OBJECTION TO PLANNING APPLICATION REF: 242066

Ascot House, Finchampstead Road, Wokingham, RG40 2NW.

16th Nov 2024

Fig 1

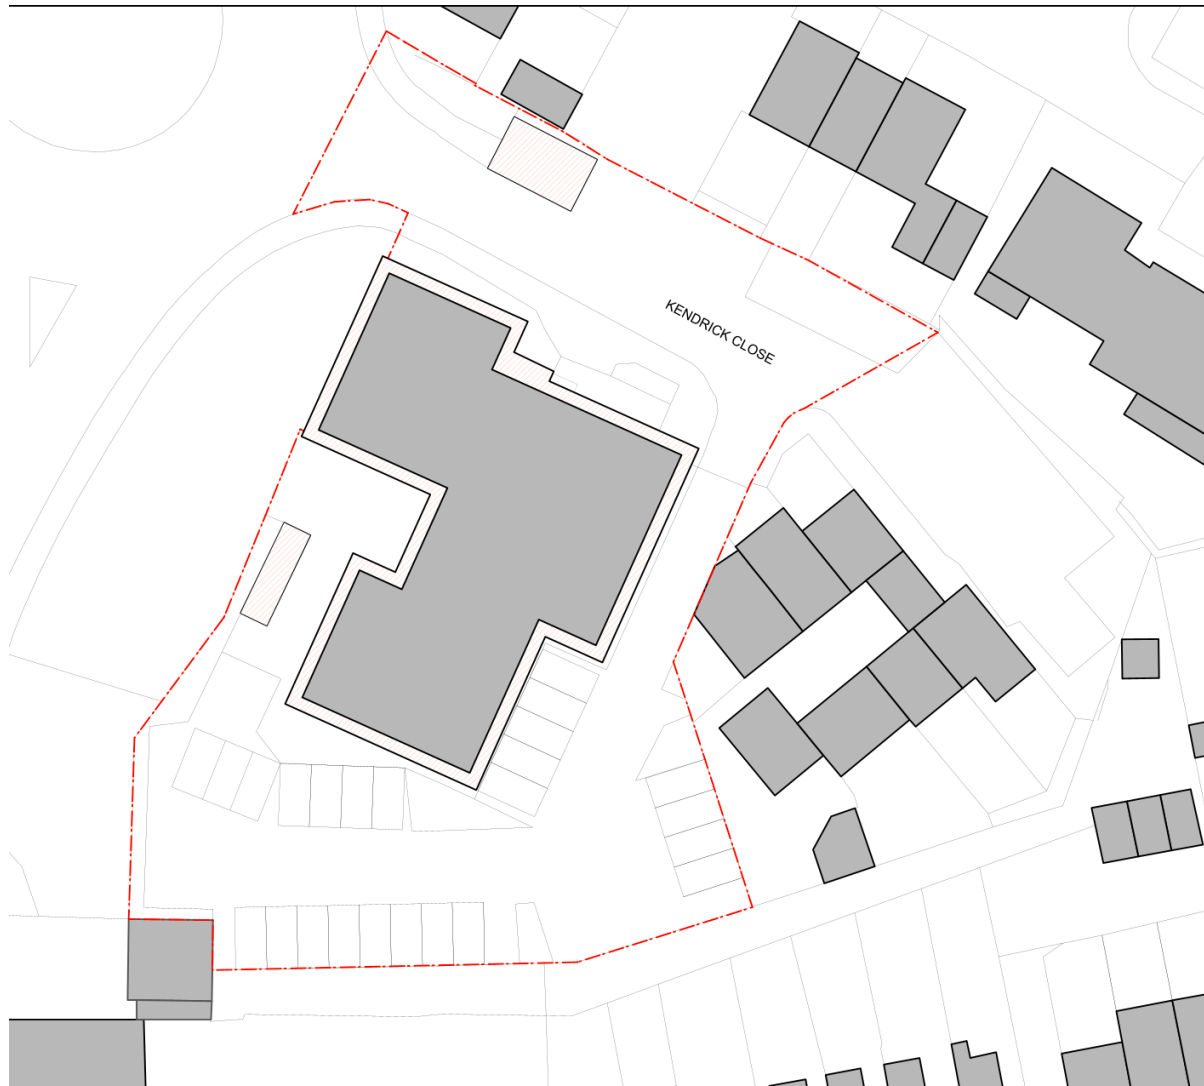
Reviewing current site permissions, all x24 approved spaces for the current residential development should be located to the southside of the current building as stipulated in the permitted site plan drawing 311_PL1_S_03 P1 of permission 211020 (**Fig 1**).

Extract of approved site plan 311_PL1_S_03 P1 listed in the latest June 2021 site planning permission 211022. Note, no approved parking arrangement or layout adjacent to/on Kendrick Close
